Industry Proposed Responses to NRC Initial Comments on NEI 14-09, Guidance on Part 21 Evaluation and Reporting

Industry proposed changes to NEI 14-09, Guidance on Part 21 Evaluation and Reporting, in response to NRC comments at a public meeting on October 16, 2015 are provided below. Proposed changes are also discussed for two clarifications identified by industry.

Appendix A, Page 63 (Figure A-1)

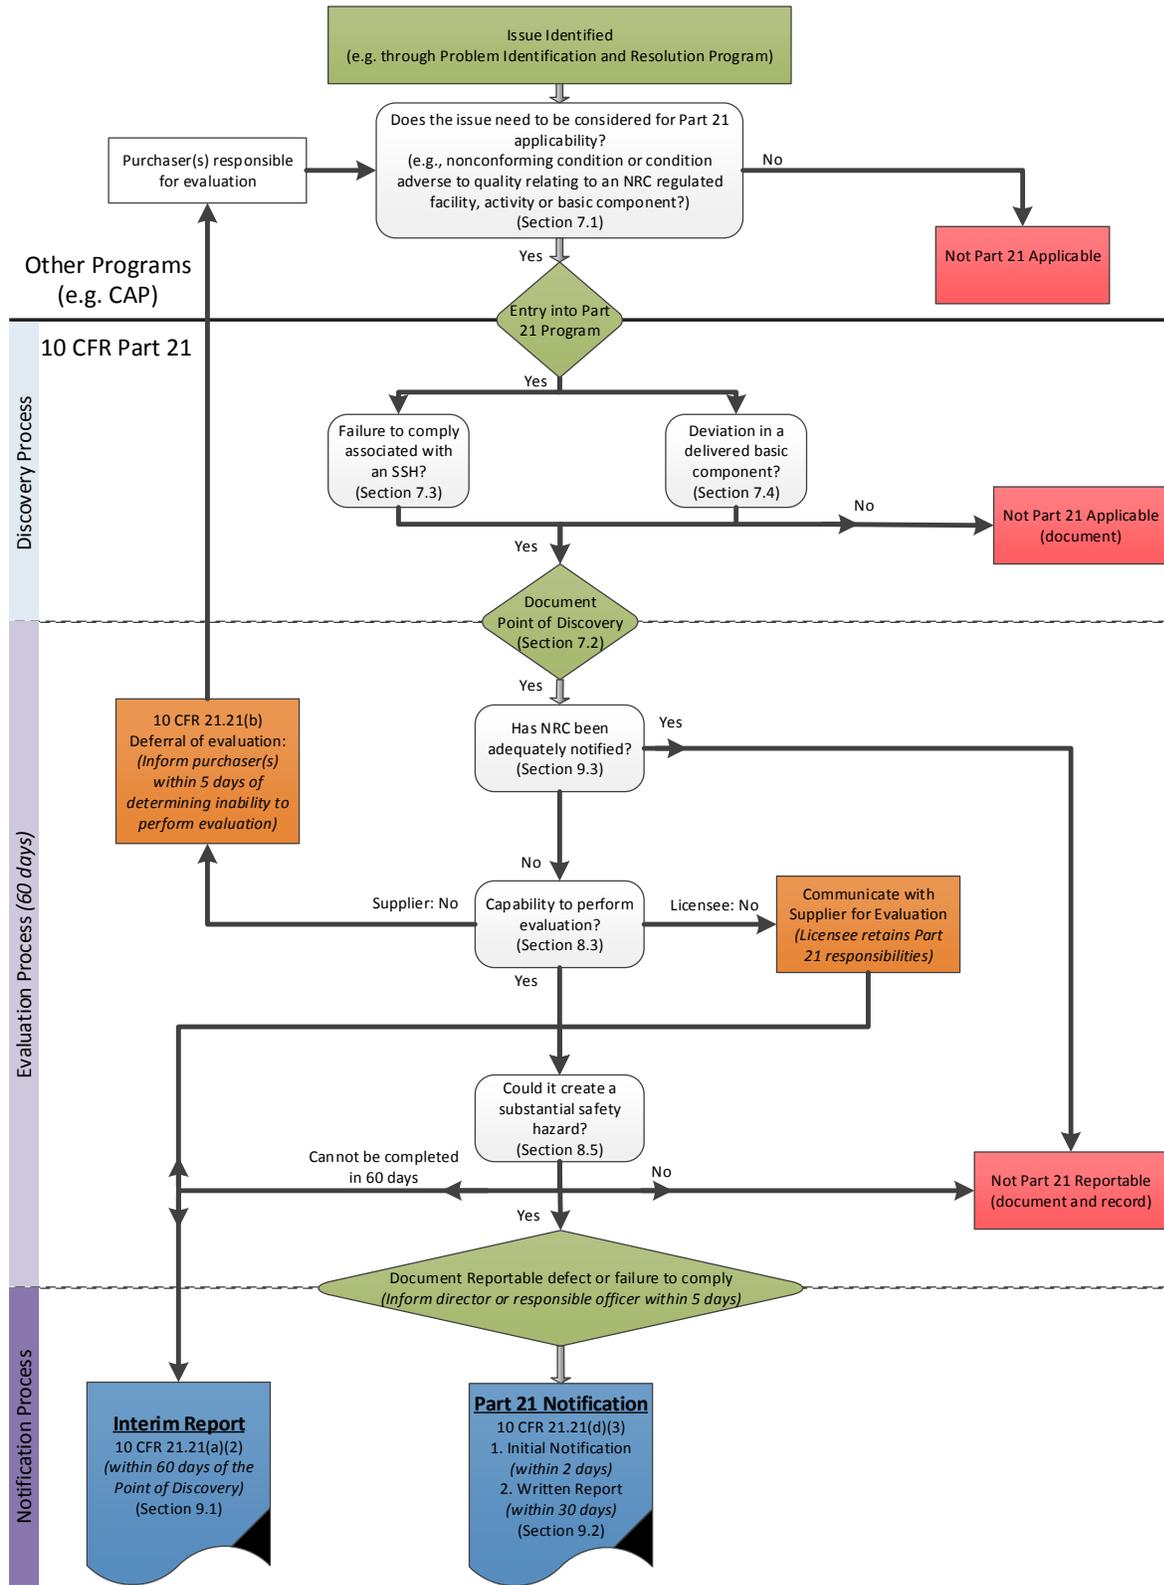
Point of discovery; Sections 2.8 and 7 are confusing when compared, and no clear distinction between discovery and evaluation

Updated Sections 2.8, 7, and 8 to clarify the distinction between discovery and evaluation and to be more consistent with each other and the Appendix A flowchart. See the track-changes version of NEI 14-09 in these locations:
